Sydney Opera Housing Building Renewal Statement of Environmental Effects Section 4.55(1A) Modification

Prepared for the Sydney Opera House Trust
Submitted to the Department of Planning and Environment

SSD 7665
Modification No. 1
August 2018

Figure 3: Location of proposed works (Source: Tonkin Zulaikha Greer Architects)

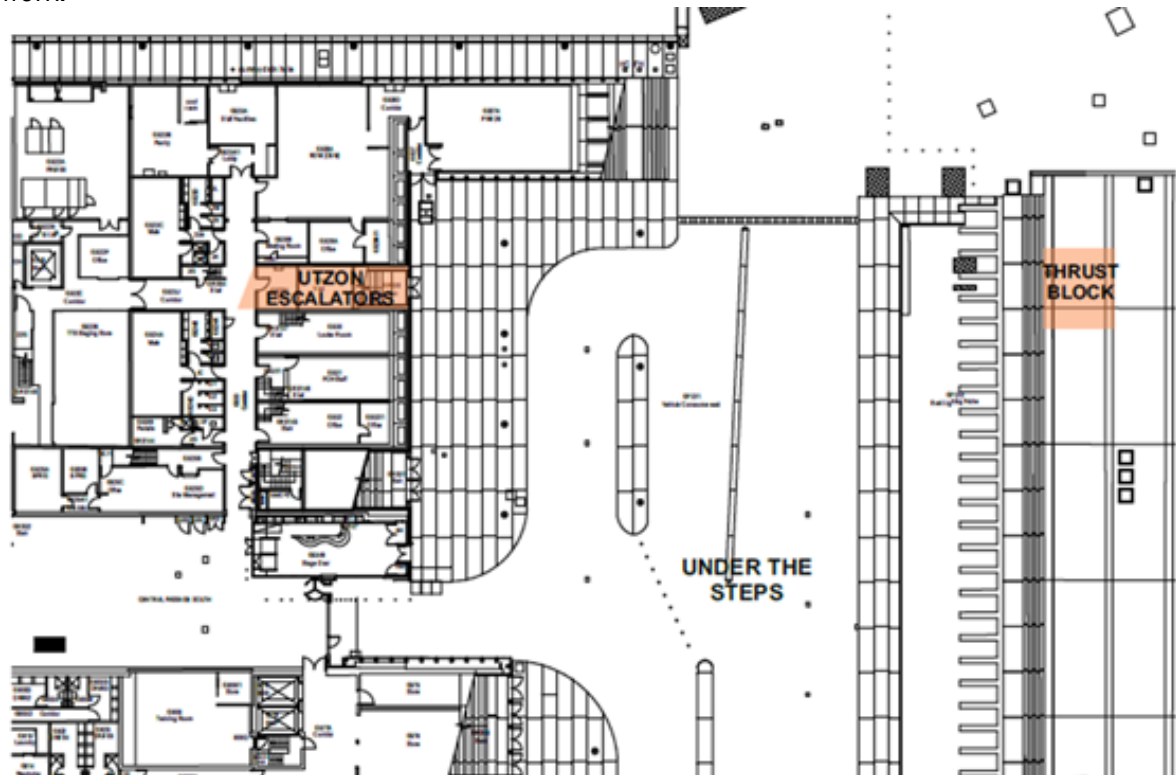
The approved Utzon escalator (SSD 7665) requires a pit at the base of the existing stairs (Figure 3 - 4). The proposed modification has arisen from further detailed engineering design work.

Figure 5: Tie-beam detail section (Source: Tonkin Zulaikha Greer Architects)

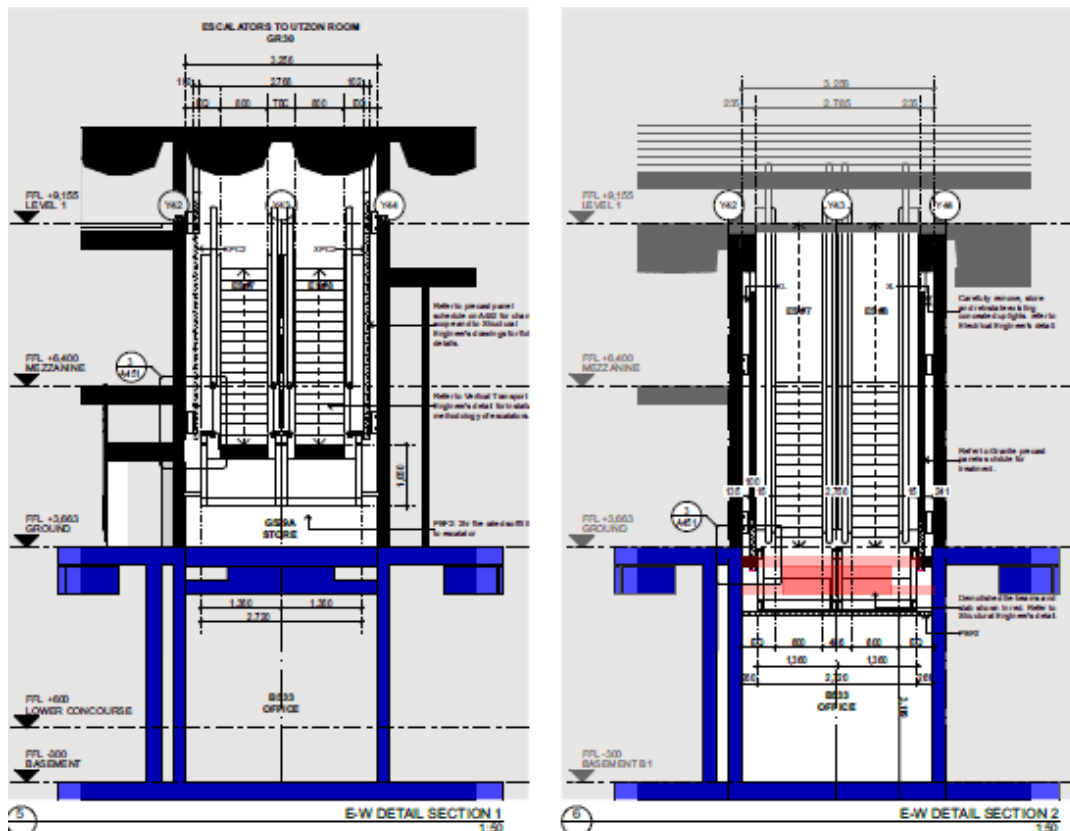
The proposed works include the cutting and modification of the north-south tie beams, which restrain the folded beams supporting the Monumental Steps and will allow for the escalator pit (Figure 5). A 'thrust block' is then required to restrain the Monumental Steps and folded beams in the permanent condition (Figure 6).

Figure 6: Thrust Block Section (Source: Tonkin Zulaikha Greer Architects)

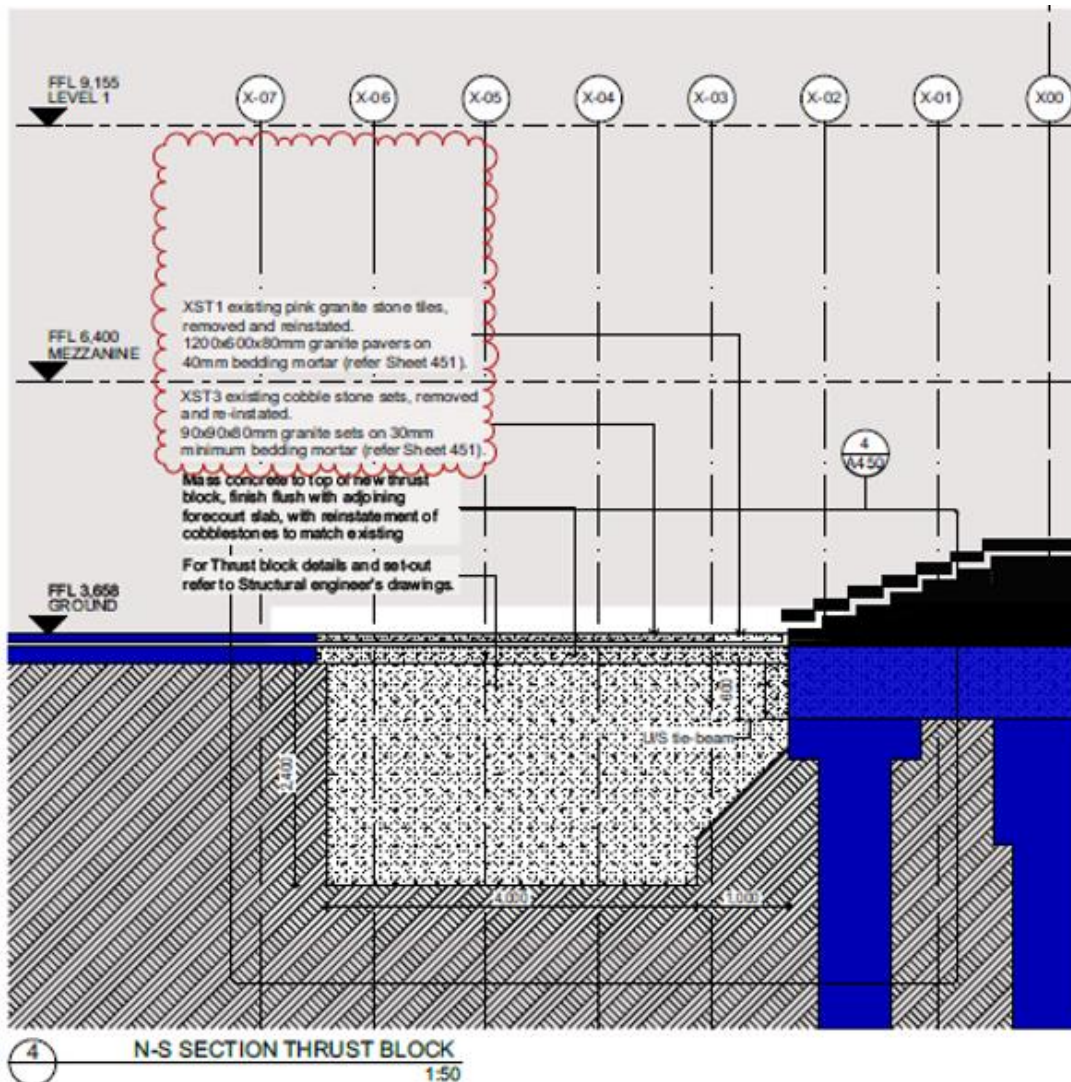
The dimensions of the thrust block are approximately 7 m (east to west) by 5 m (north to south), with a depth of 2.5 m from the ground level. It will require the excavation of a trench 9 m (east -west) by 6 m (north-south) by 3 m deep to install the thrust block (total size of excavation area is 54 m²). A works buffer zone of 14 m by 14 m will be required.
